Product/Process Change Notice (PCN)

PCN #: PCN_IndGFH_20180429

Product Affected: WE-GFH size 3225 series

DETAIL OF CHANGE:

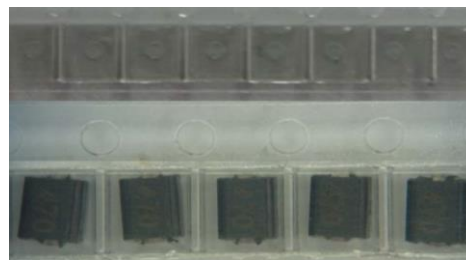
In order to enhance the product reliability, Würth Elektronik will change the carrier tape type for a new version with a stable peel strength for the series WE-GFH size 3225.

Implementing a new version of carrier tape will improve the process of adjusting Pick & Place parameters at the customer side. With improved adhesion technologies, the tape now has a better and stable removal process. Before we experienced deviations in the process of peeling force.

This change is only affected by the series WE-GFH size 3225 with the following article reference "7447649xxx".

The visual difference between the new and current tape will be appreciable with the colour. Next picture shows the colour differences. At the right side we have the new one which is lightly darkened that the current one, at the left side.
